Subject: **Application for Modifications to CWA Section 404 and 401 permits and CAMA Major permit for the NC 55 Widening. NC 55 Widening From US 17 in Bridgeton to NC 304 in Bayboro. Craven and Pamlico Counties. State Project No. 8.1170901. Federal Aid Project STP-55(1). TIP No. R-2539B. Debit \$475 from WBS Element 34452.1.2**

The purpose of this submittal is to request a modification to the Section 404 permit and Section 401 Water Quality Certification and refinement to the CAMA Permit, specifically for Section B. The NCDOT proposes to revise a drainage system east of an unnamed tributary to Black Creek in order to accommodate removal of 3 preformed scour holes (PSH). The PSHs were originally proposed as on-site water quality treatment. However, during construction, the 3-foot and 4.5-foot hole depths required to

Memorandum of Drainage Revisions

RE: R-2539B
Drainage Design Revisions
Plan Sheets 19-23

N.C. DEPT. OF TRANSPORTATION
 DIVISION OF HIGHWAYS
 PAMLICO COUNTY
 PROJECT 8/1170901 (R-2539B)
 NC 55 FROM EAST OF SR 1127 TO EAST OF
 SR 1129
 SHEET **17** OF **40**
 04-18-2005

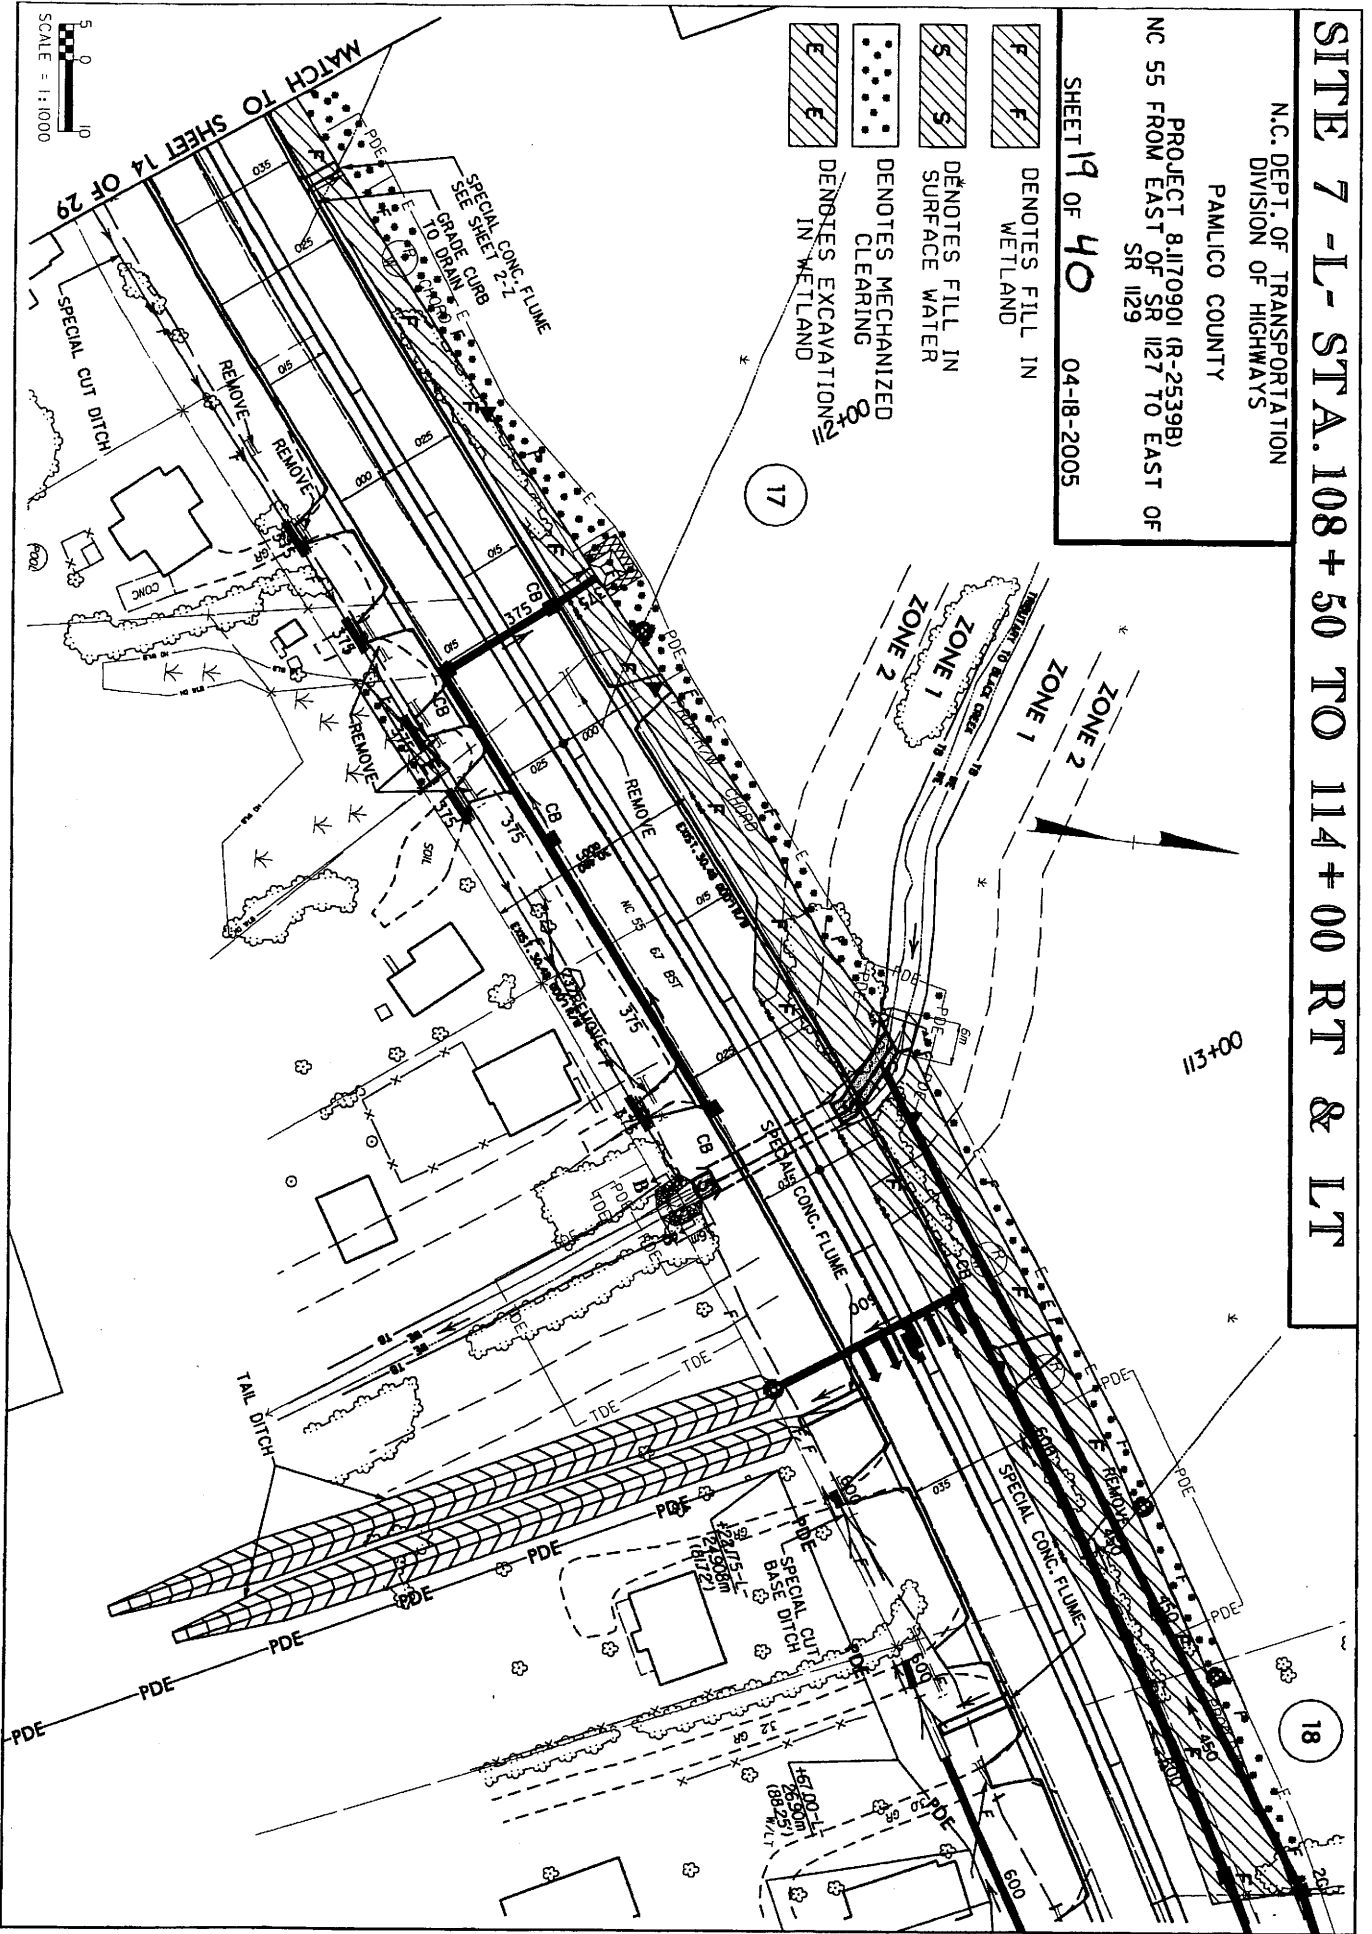
- Wetland impacts reduced by removing design for 3 PSHs at Stations 111+31 left, 113+42 left, and 113+58 left
- Within a non-jurisdictional area - eliminate cross pipe at Station 110+50 (under pavement)
- Within an already permitted wetland impact area - install special cut ditch and driveway pipes from Stations 109+20 to 112+75 right (crosses tip of small wetland; alternative would have been to install ditch on left side of road, which would have affected a much larger wetland system)
- Within an already permitted wetland impact area - redesign drainage system of pipes from Stations 112+80 to 121+10 left to outlet into grassed swales at Station 113+20 right.

R-2539B	
R/W SHEET NO.	
ROADWAY DESIGN ENGINEER	HYDRI ENC
PRELIMINARY PL DO NOT USE FOR CONSTRUCTION	
INCOMPLETE PL DO NOT USE FOR R/W ACQUISITION	
CONST. REV.	
R/W REV.

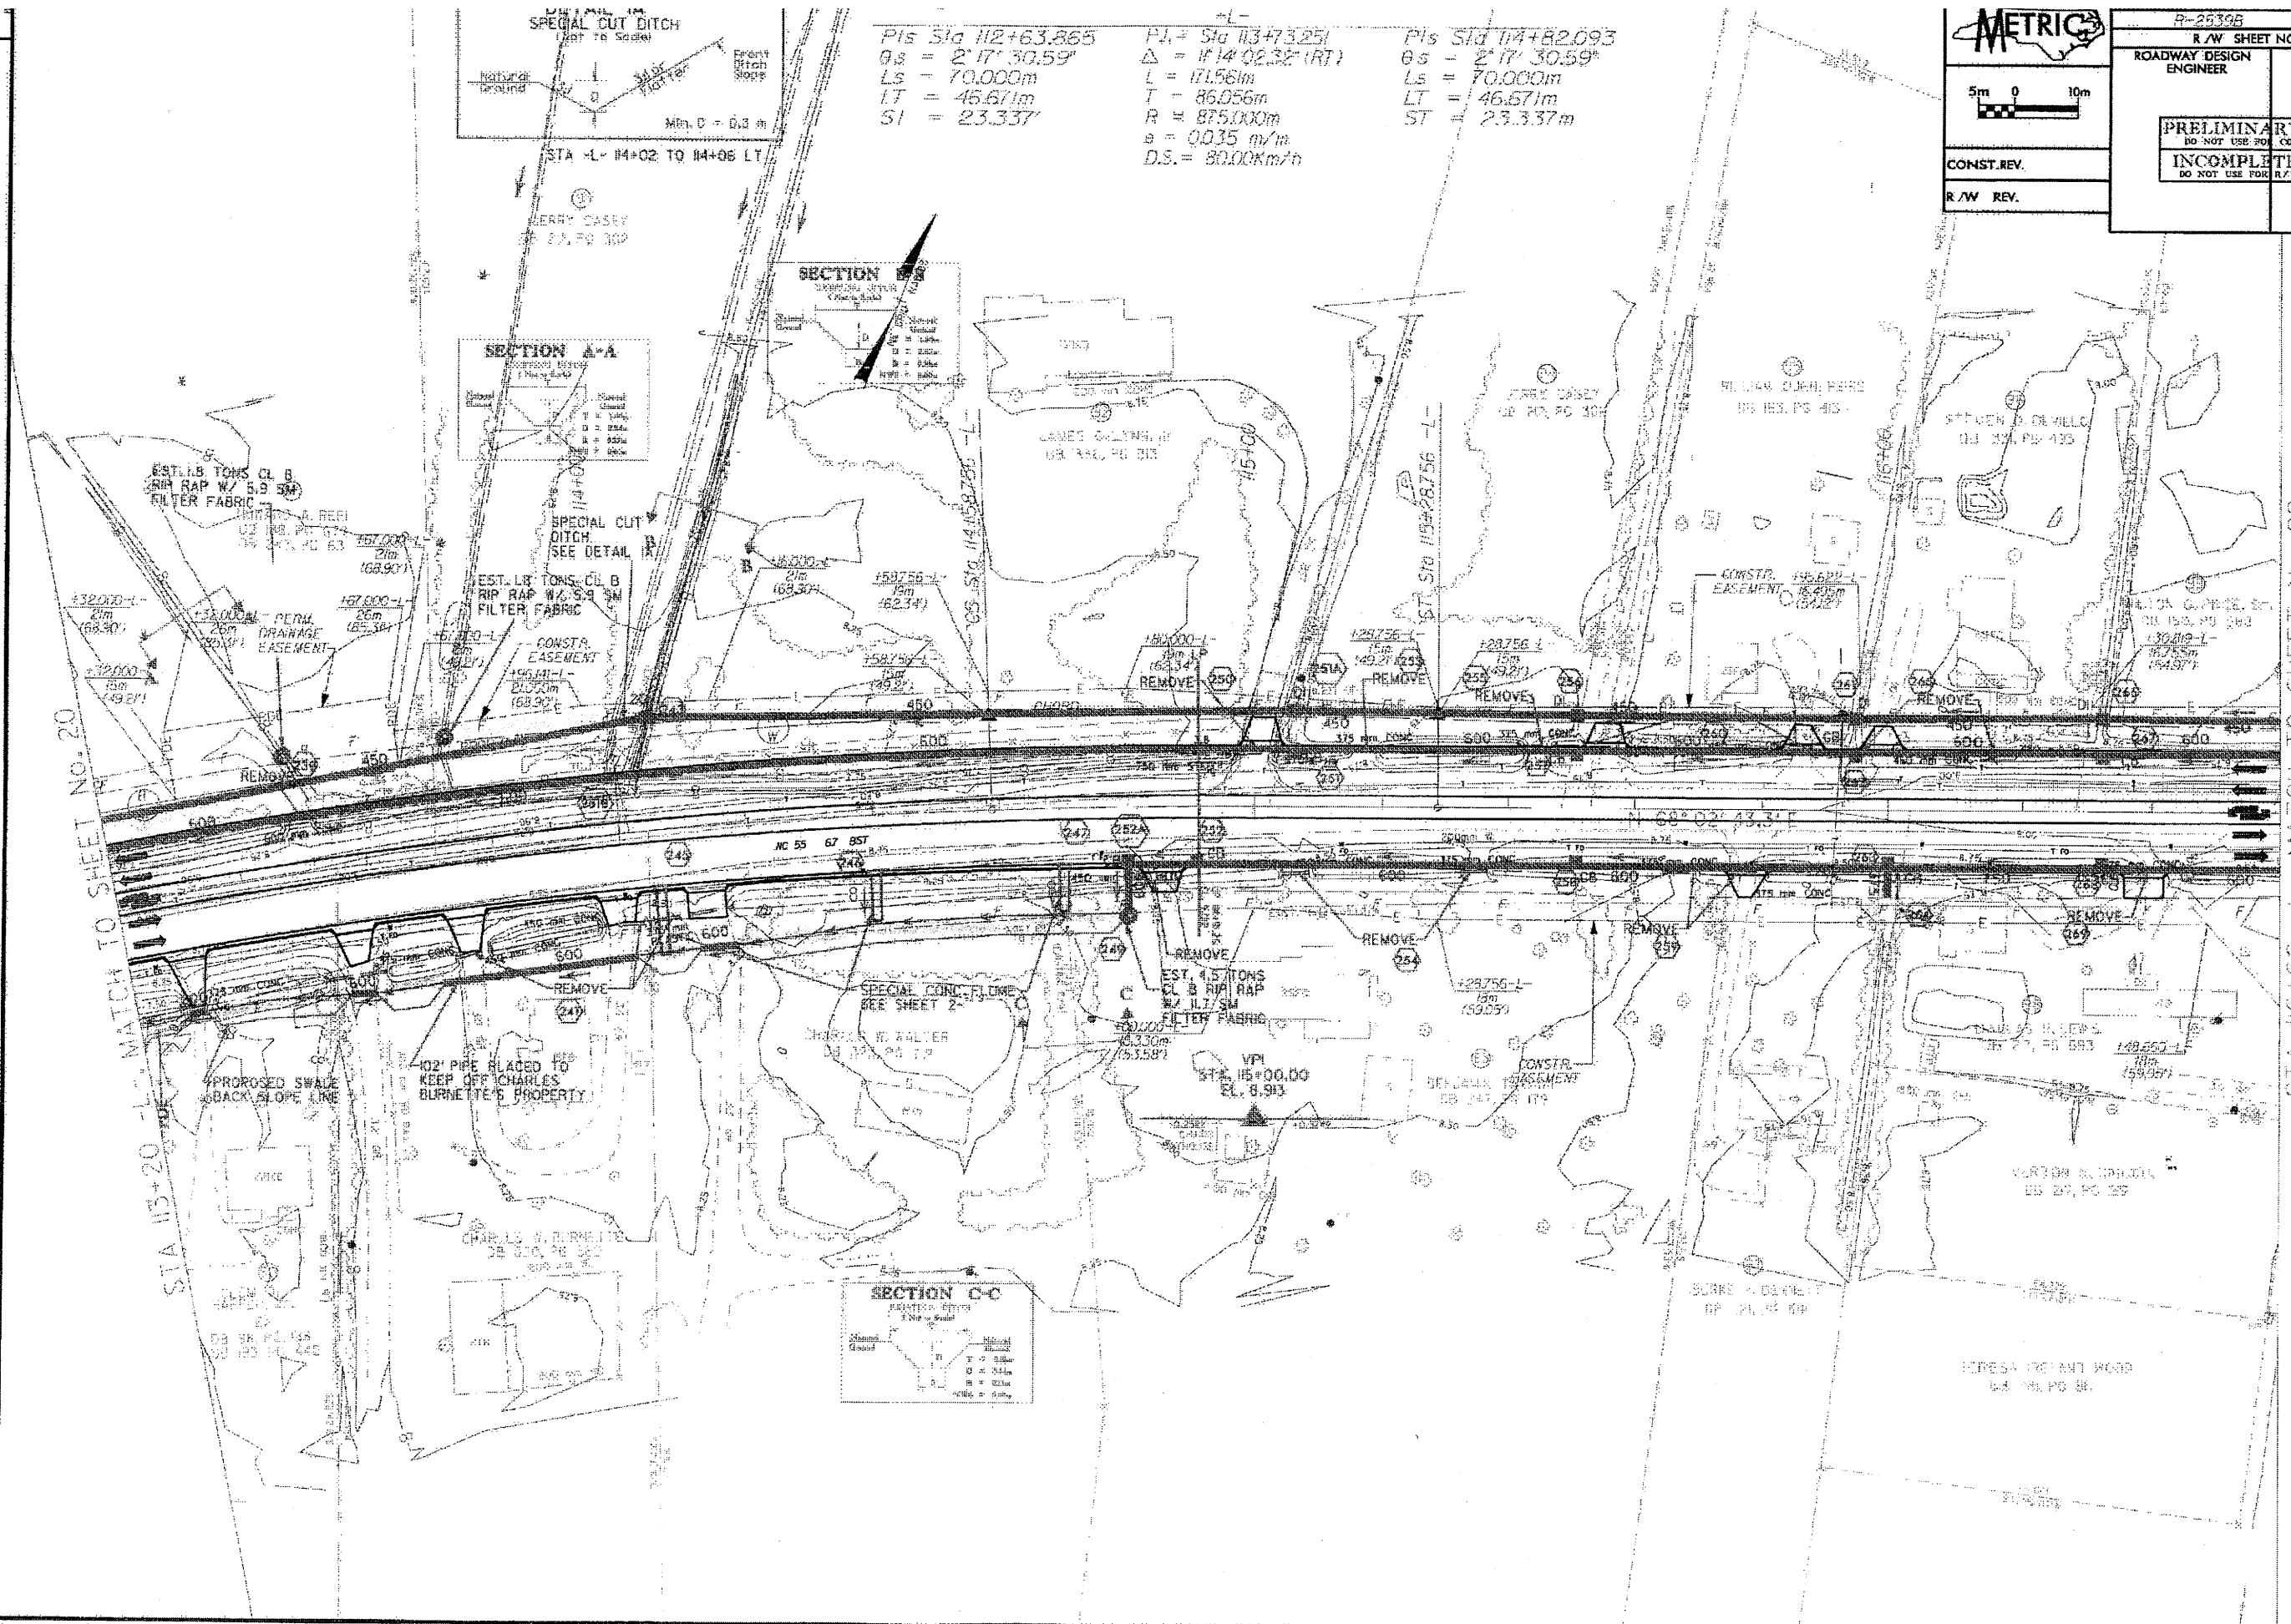
1. Drainage system from 109+50 to 111+30 left has been eliminated through use of flumes in place of catch basins. Sheet 2-Z will be added to the plans to detail this special flume construction.

2. Cross pipe at 110+50 has been eliminated. A special cut ditch and driveway pipes have been designed from 109+20 to 112+75 right to carry drainage to culvert site. The back slope of the ditch will tie very close to the existing easement / right of way and therefore, no additional easement is proposed.

3. A drainage system has been designed from 112+80 to 121+10 left to carry the off-site "clean water" directly to the Black Creek Tributary. Additional easement is required from the DeVillo property at 115+95 to 116+31 left and the Goodwin property at 116+96 to 117+18 left.

4. The on-site "dirty water" has been divided into a left and right system and discharged into swales of sufficient length for on-site treatment. Construction of the swales will require additional easement from the Harper, Burnette, Walter and Taylor properties from 112+80 to 114+85 right.

In lieu of the scour holes, the revised plans will achieve water quality through construction of a parallel pipe system from -L- Station 112+80 to 121+10 left that intercepts off site water and discharges this "clean water" directly into the Black Creek Tributary. Also, the on-site "dirty water" will be collected in systems on the left and right and discharged into proposed swales. These swales are of sufficient length for treatment prior to discharge into the Creek.
